FCO CA12621: Coolant upgrade procedure, dual head

Internal document number: 719-00872A-B

Product
Kodak Trendsetter® NEWS

Component Heat exchanger

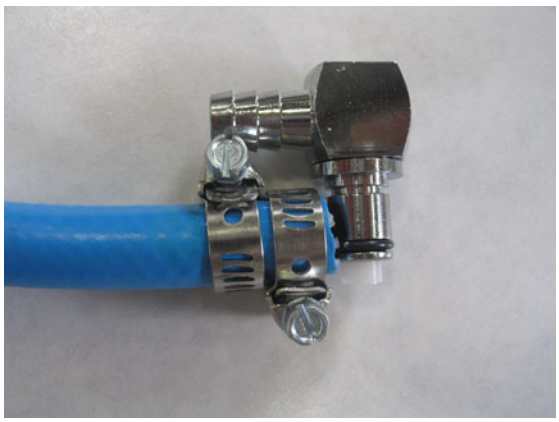
All male hose connections must be replaced. There are five on the device – one at the reservoir connection and four at the heads. For each connection:

1. Cut the hose just below the ferrule.

2. Install two hose clamps per male fitting as shown in the photo.

3. Press in a new male connector.
4. Tighten the clamps.
5. Replace the old reservoir cap on the reservoir connector with the new reservoir input cap (50-2164B).
6. Ensure the strainer is clean and in place.
